Access Compliance Report

Public Rights-of-Way

Intersection ID: 10039626	Main Street: THORNTON_RD	Cross Street: N/A	Location: SE
ADA ID: 8F6D74CC1305	Ramp Type: Perpendicular	Initial Pass/Fail: Pass	Overall Compliance: No
Codes/Mitigation Info/Possible Solution		Field Measurements/Component Compliance

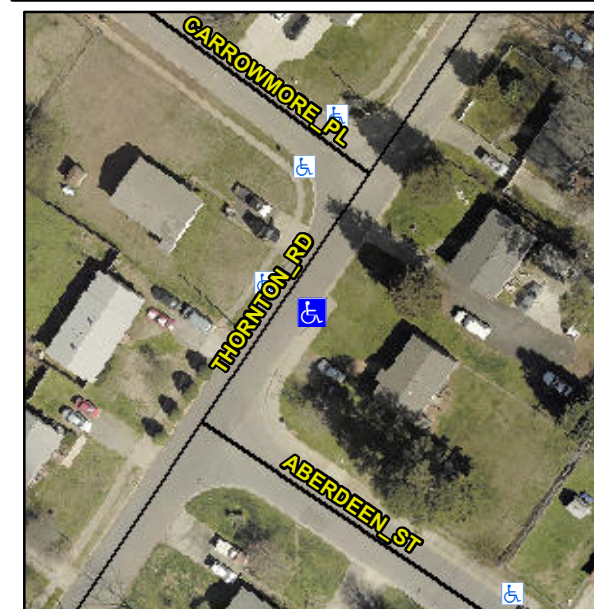
Not Found, R304.2.1, R304.2.2-Perp, R304.3.2-Para, R304.5.3

Compliance	Description	Data	Compliance	Description	Data
N/A	Ramp Length (in)	71.5	Yes	Ramp Slope (%)	5.9
Yes	Ramp Width (in)	48.0	Yes	Ramp XSlope (%)	0.7
N/A	Flare Type LT	Sloped	N/A	Flare Type RT	N/A
N/A	Flare Slope LT (%)	6.4	Yes	Flare Slope RT (%)	3.8
N/A	Flare Traversable LT?	Yes	N/A	Flare Traversable RT?	Yes
No	Landing Length (in)	N/A	Yes	DWS Provided?	Yes
No	Landing Width (in)	N/A	Yes	DWS Contrast?	Yes
No	Landing Slope (%)	N/A	Yes	DWS Length (in)	24.0
No	Landing X Slope (%)	N/A	Yes	DWS Full Width?	Yes
N/A	Landing Curb? (Y/N)	No	Yes	DWS Offset (in)	0.0
N/A	Shared Landing?	No			
Yes	Gutter Ponding?	No	Yes	Gutter Slope (%)	2.6
Yes	Gutter Lip Ht (in)	0.0	Yes	Gutter X Slope (%)	0.3
N/A	Painted X Walk1?	No	N/A	Painted X Walk2?	N/A
	X Walk 1 Direction	To NW		X Walk 2 Direction	N/A
N/A	X Walk 1 Width (in)	N/A	N/A	X Walk 2 Width (in)	N/A
	X Walk 1 Slope (%)	4.2		X Walk 2 Slope (%)	N/A
	X Walk 1 X Slope (%)	0.6		X Walk 2 X Slope (%)	N/A

N/A	Ramp inside XWalk1?	N/A	N/A	Ramp inside XWalk2?	N/A
	Road Slope (%)	N/A	N/A	Clear Space?	Yes
	Road X Slope (%)	N/A	N/A	Clear Space to XWalk (in)	N/A
Yes	Any Obstructions?	No	Yes	Storm Grate/Utility Hazard?	No
	Obstruction Type			Storm Grate/Utility Type	
		N/A			N/A
			Yes	Surface Condition? (G/P)	Good

Remove & Replace Entire Ramp.
